☐ Noonan_HW4_final_answers.md

HW 4 Challenge and Discussion Questions: Well, Well

Model Description

Figure 1: Base case boundary flows.

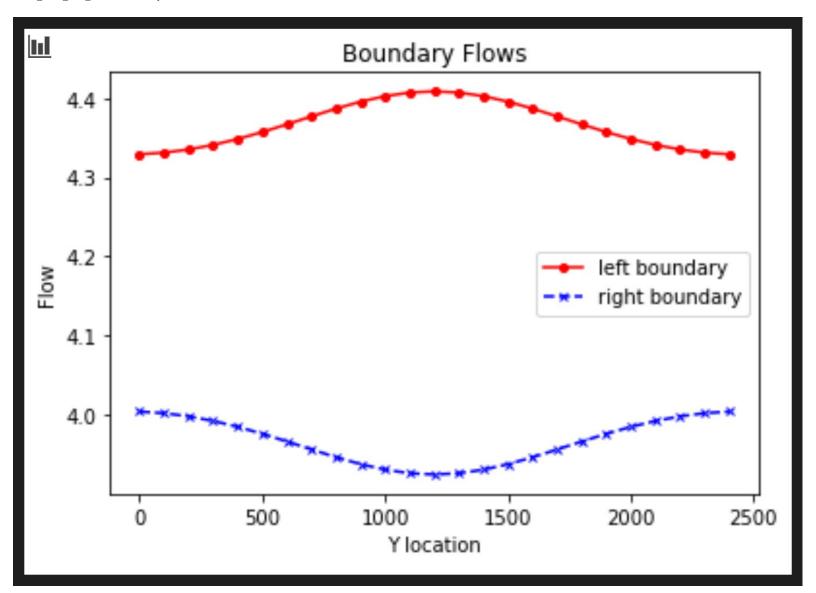
Ty Feedback: You are right that the response is similar ... just be a bit more specific about WHY the well leads to this flow distribution.

Amended Answer: You can see that the flow is higher towards the middle of the boundary and lower to the top and bottom on the left side (flow source), and the opposite is seen on the right hand side where the flow is lower near the center of the boundary and a little higher to the top and bottom. These curved shapes reflect the location of the well, which is pulling water from the left boundary, and capturing water that would have made it to the right boundary. Thus the related flow increase and decrease at the center of the boundaries (well location) at the left and right boundaries, respectively.

Figure 2a: Base case boundary fluxes and flux through midline of domain and flux through just upgradient of well..

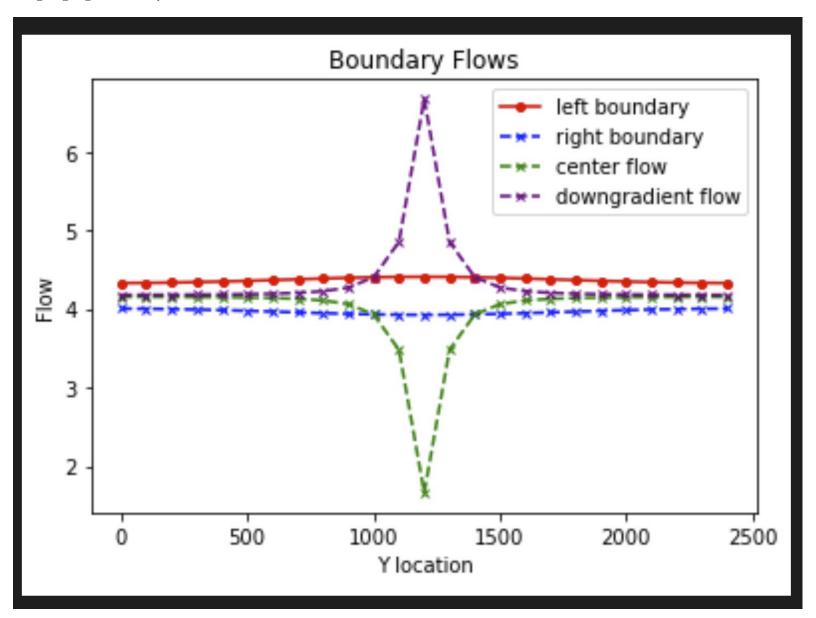
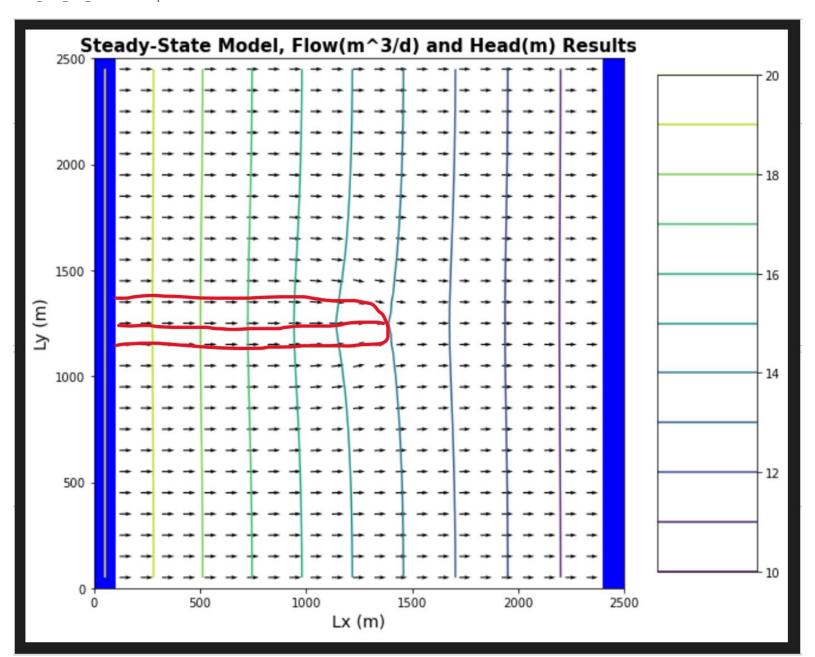
Ty Feedback: You are on a good track. Try thinking holistically about how flow is occurring to/into/from the well and rework your answer slightly. For example ... is water getting backed up anywhere?

Amended Answer: After lecture today and thinking about tracking a flow particle, I no longer think that water is getting backed up per say, it is either going into or through the well or around the well and at different speeds, so maybe poor choice of words. From the flow line that goes through the center (through the well) in Figure 2a, you can see that the flow decreases as it approaches the well and hits a low value of approximately 1.5 flow units at the well location. Then the flow path increases again past the well, recovering back to the original flow value. There is no point in which the flow goes negative (which would indicate flow coming from the right side - flow continues through the well to the right.

The line that shows flow just upgradient shows a flow increase just to the well and then a similar decrease to the other side of the well. From lecture today, Ty showed a profile where a line was placed from top to bottom, and remarked that more flow vectors would be encountered along this line as they are approaching the well. I think this is what accounts for the increased velocity - it's not just the flow from the center going around, but flow coming in from other areas of the "capture zone" toward the point of the well.

Figure 3: Base case equipotentials and flow vectors.

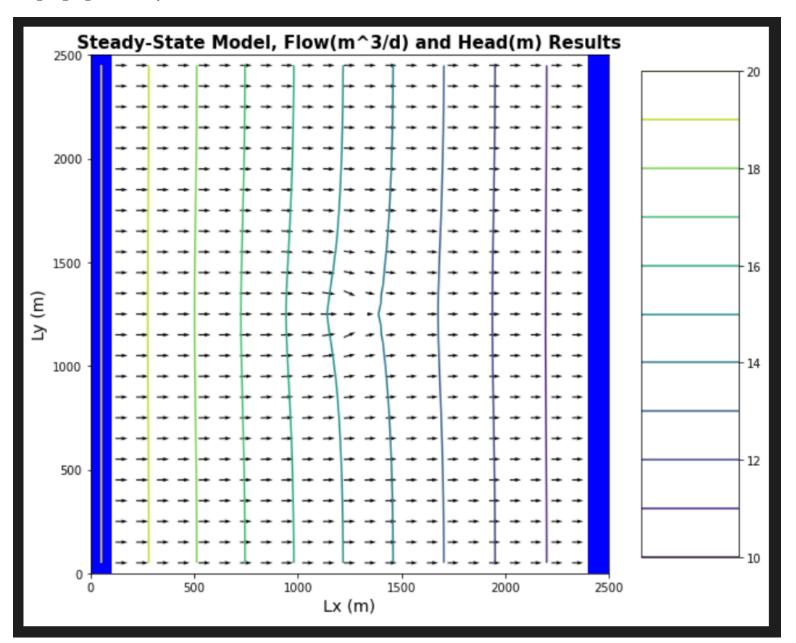
Ty Feeback: Good answer! Combine this with #2 to intuit what is happening just outside of the capture zone, directly downgradient from the well.

Amended Answer: Yes, I think you are talking about noticing that the flow vectors are all headed towards the well.

Figure 4: Base case drawdown around centered well - simply python plot.

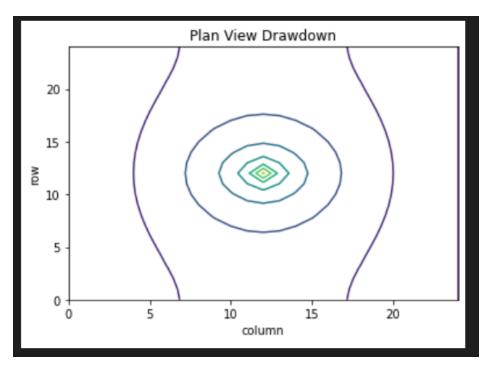
Ty Feedback: This is partially correct. Just explain WHY the boundaries impact the drawdown. In answer to your question, for a confined aquifer the gradient does NOT impact the drawdown. But, there is one more thing. Right near the well the drawdown should be circular. Why isn't it on your plot??

Amended Answer: This one is still a little fuzzy for me, even after re-listening to the lecture. Facts: The boundary restricts the flow. The "circles" are stretching vertically and compressed horizontally. All flow is coming from the left to the right. No flow is coming from the top. They should be circular

Figure 6: [0,5,5] equipotentials and flow vectors.

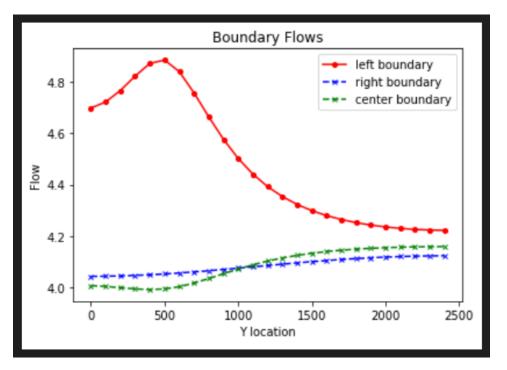
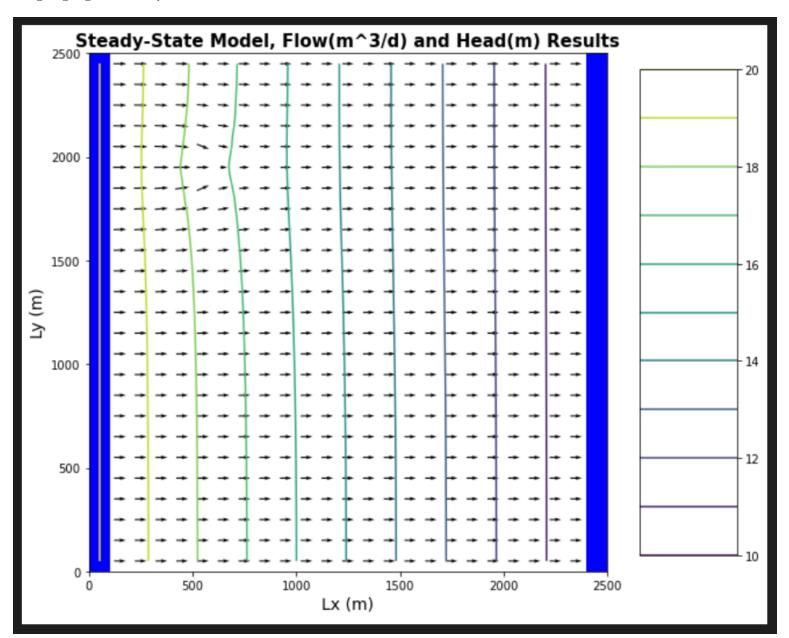
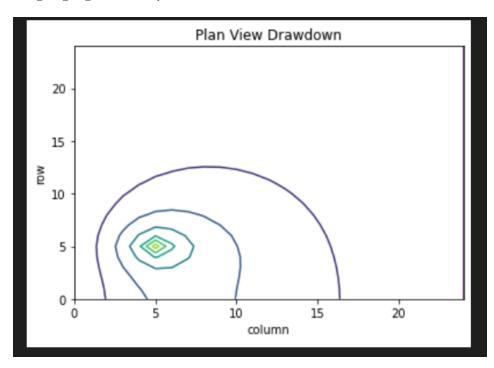
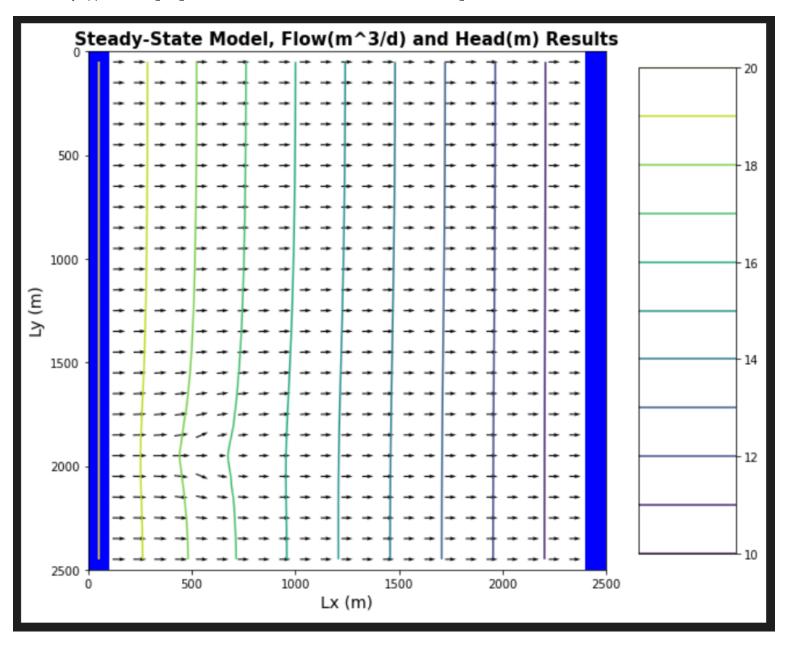
Ty Feedback: Good thinking on the boundary fluxes. Can you think of a way to compare the results for the centered and non-centered wells QUANTITATIVELY? Good that you caught the 'flip'. To answer this, think about how matrix rows are defined in python versus MODFLOW. Keep this in mind if you make your own plots (not using the built-in FloPy utilties)!

Amended Answer: I'm thinking the answer here on how to compare quantitatively might be the example discussed in the bonus assignment below - what does the area within the curves mean?

For the plot fix - I now know it has to do with how Modflow/FloPy (bottom to top) count rows versus how matplotlib/Python counts rows (top to bottom). I tried to fix this by inverting the axes (looked up a line of code (plt.gca().invert_yaxis()). However, it messes up the flow vectors. Now they appear to be going around the well instead of towards the well. What gives???
